Smart Construction Pilot v1.0.03 Updates

Re-select the region code

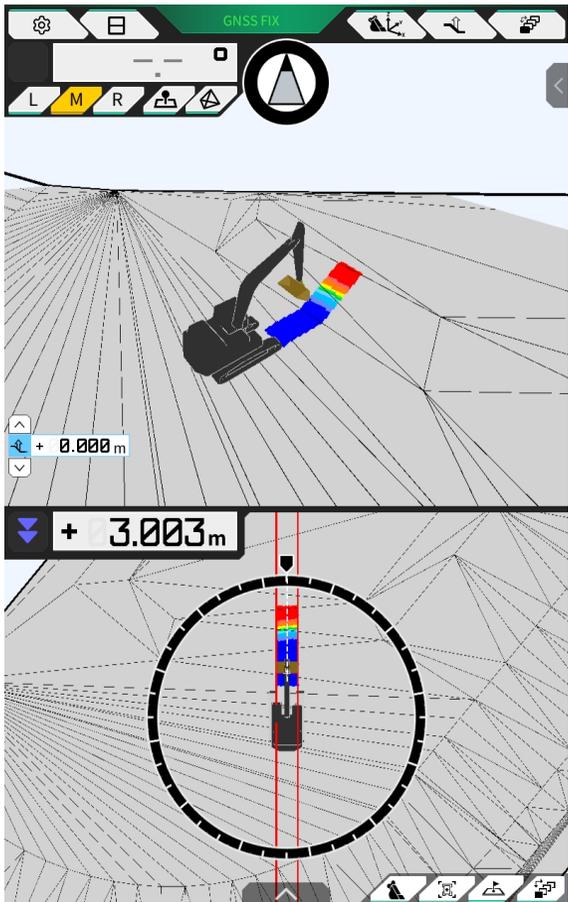
When the application is updated, a screen will be displayed to re-select the region code.

There was a problem with the region code used in “Payload Meter”, so please re-select “Region” when updating the application.

Plan view changed (including ON/OFF-toggle “Bucket Width Line”) + heatmap added in 3D/3DMesh-view

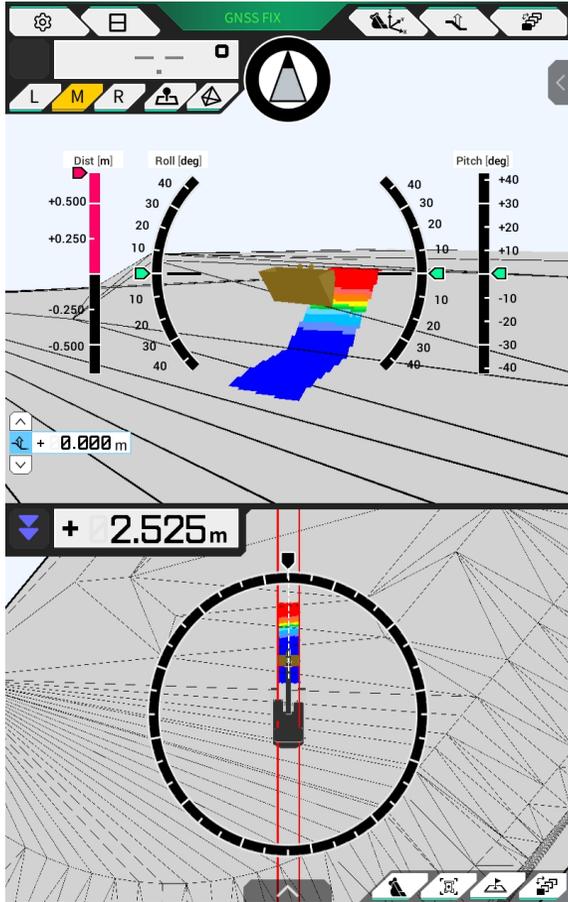
The Plan view will be changed to a camera-view directly above the machine. With this change, the “Bucket Width Line” can be toggled ON/OFF. Additionally, the heatmap is displayed in 3D/3DMesh-view now.

“Bucket Width Line”-display can be toggled ON/OFF from Menu > Guidance Settings > Application Settings

Default is “OFF”

Able to change Light Bar-width

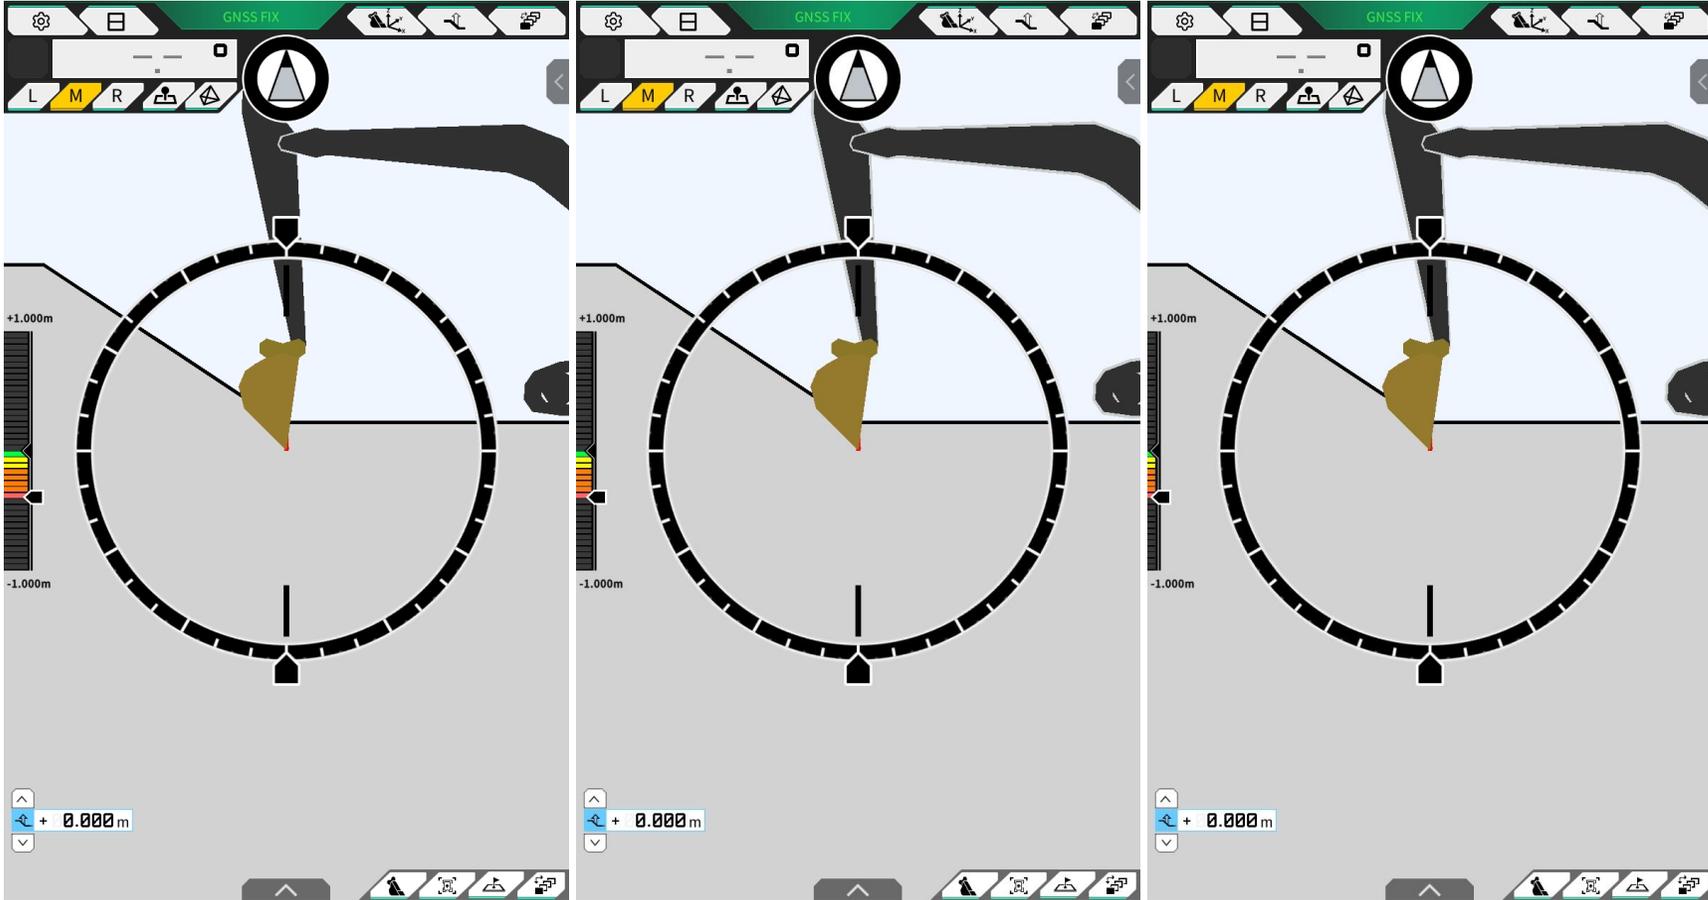
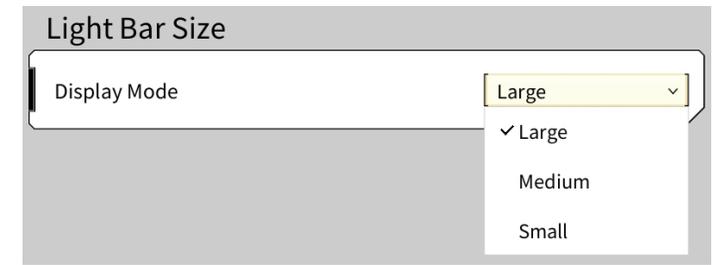
The width of the Light Bar can now be changed from "Large," to "Medium," and "Small".

“Light Bar Size” can be changed from Menu > Guidance Settings > Application Settings

Default is “Large”

Automatic tilt-deactivation when selecting normal bucket

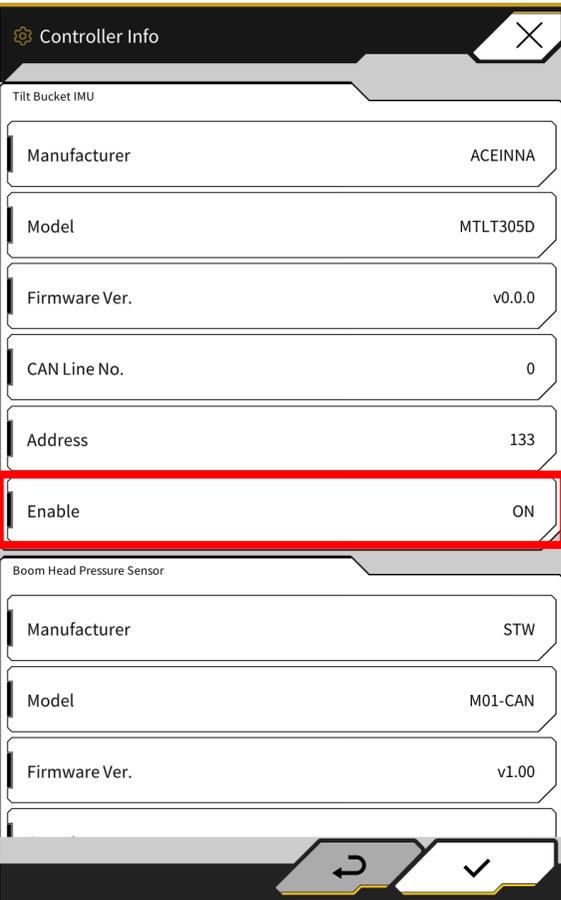
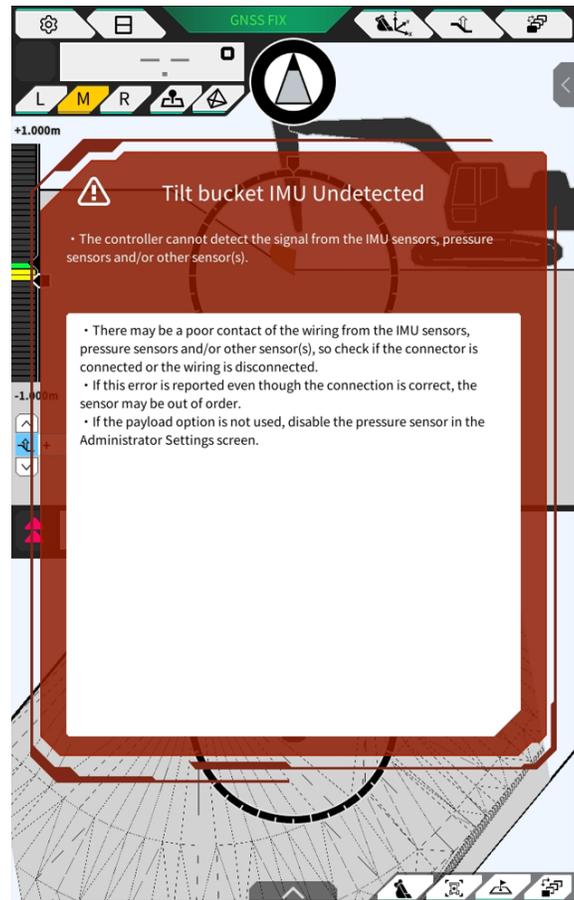
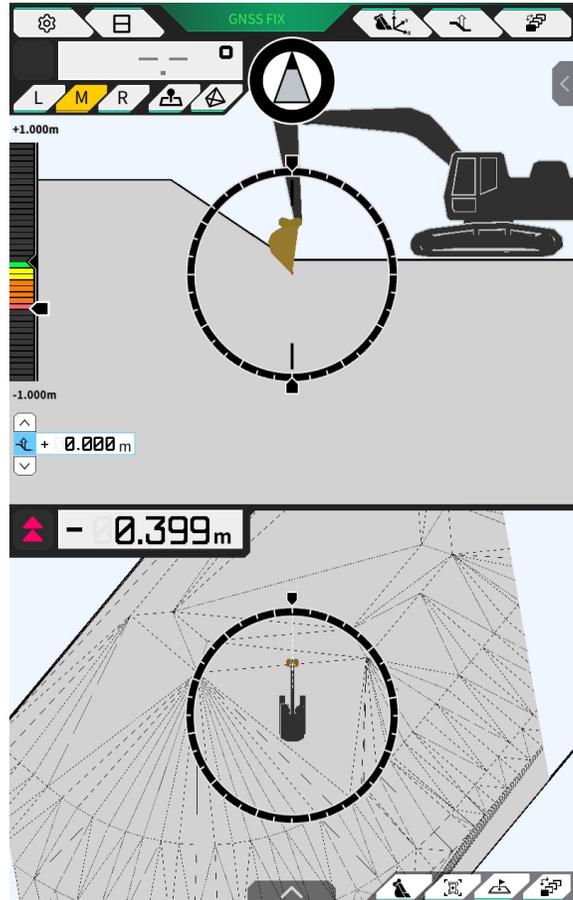
There will be no longer an error when changing from tilt-bucket to normal/slope bucket even when the tilt-imu is activated.

Tilt bucket is attached [Tilt bucket IMU error is displayed]

Standard/Slope bucket is attached [Tilt bucket IMU error is NOT displayed]

Refine your search in the projection list

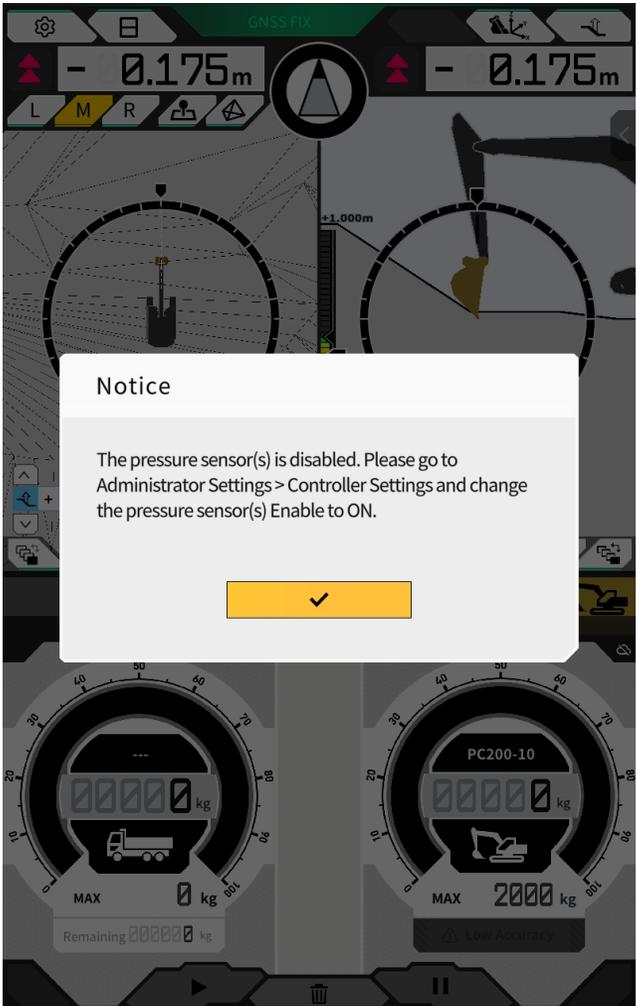
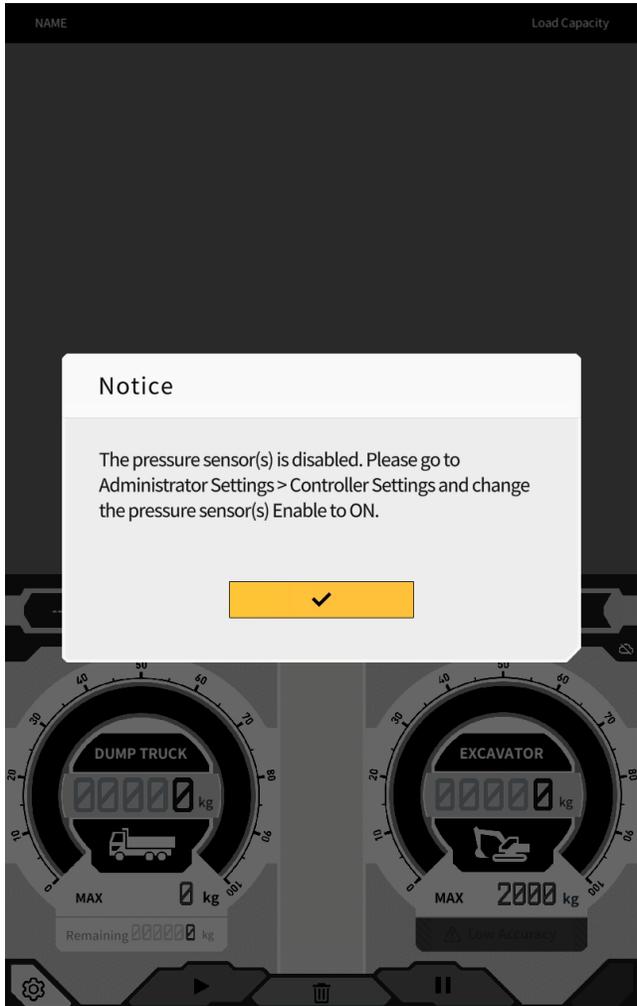
When selecting “Projection” and “Geoid Name” on the Projection Settings, you can now refine your search by inputting text.

When you tap the pull-down list, the onscreen keyboard shows up and you can refine your search by inputting text.

Show a dialog box when pressure sensor(s) are disabled

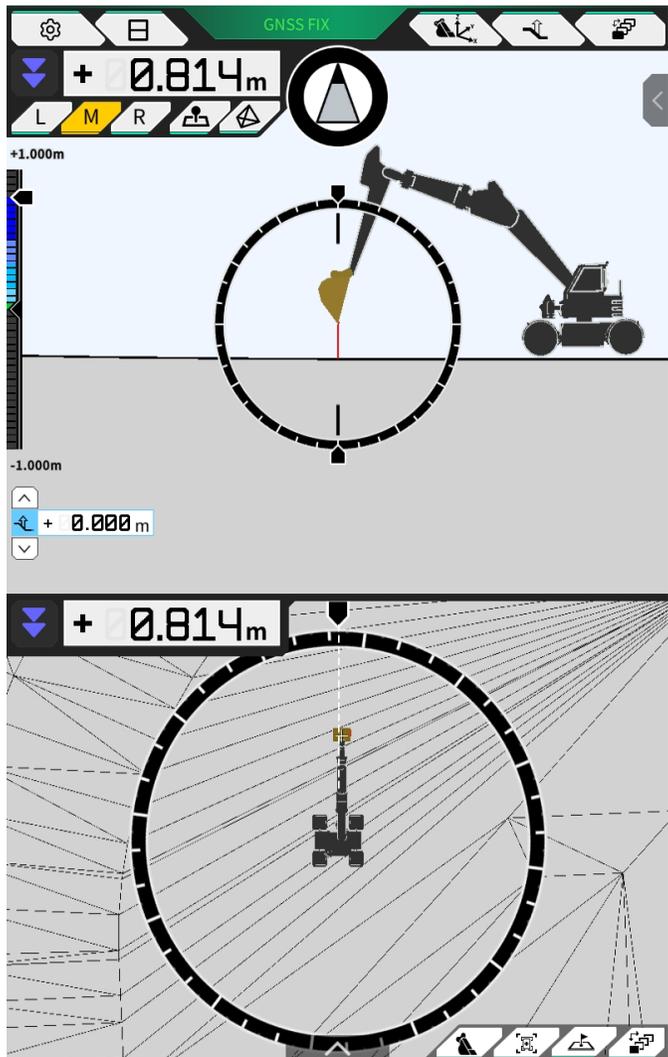
When you select “Payload Meter” or “3-display mode” in “Machine Guidance” and the pressure sensors are disabled, a dialog box will appear informing the sensors are disabled.

When the dialog box is displayed and the payload sensors are installed, follow the instructions in the notification to change the pressure sensor settings:

Administrator Settings > Controller Settings

“Machine Guidance” is now available for Swing Boom.

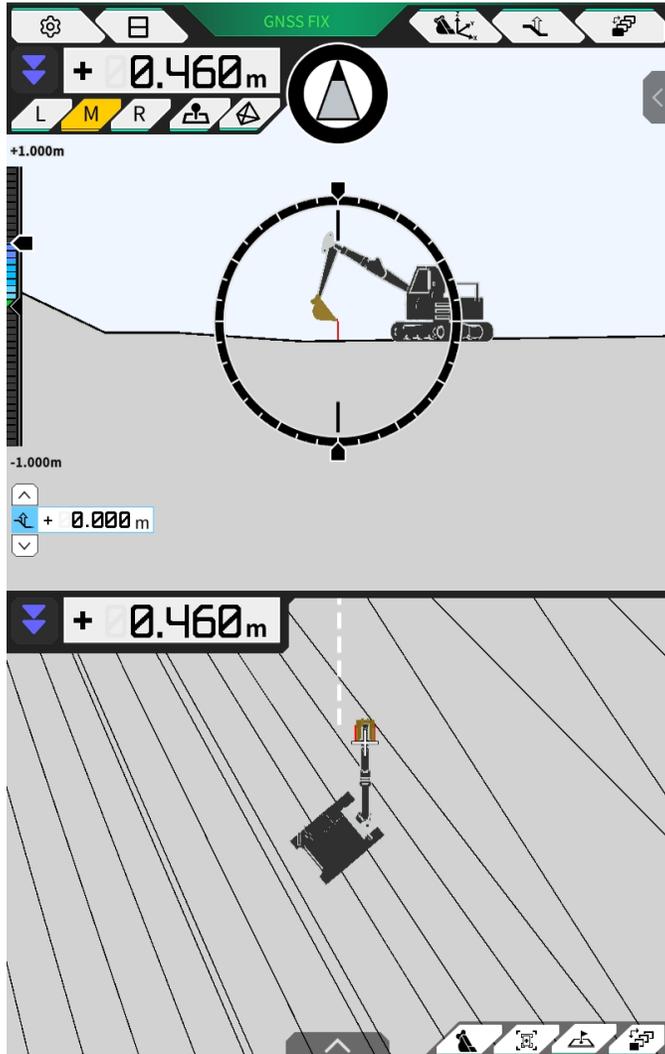
It is required to **install the swing sensor and link structure** when using a Swing Boom-model.

* **Payload Meter is unavailable** for Swing Boom

* **PC30MR is the only supported model** for now

Please turn ON “Swing Boom Function” from Menu > Guidance Settings > Application Settings, then perform Machine Calibration. After Machine Calibration, perform Swing Sensor Calibration.
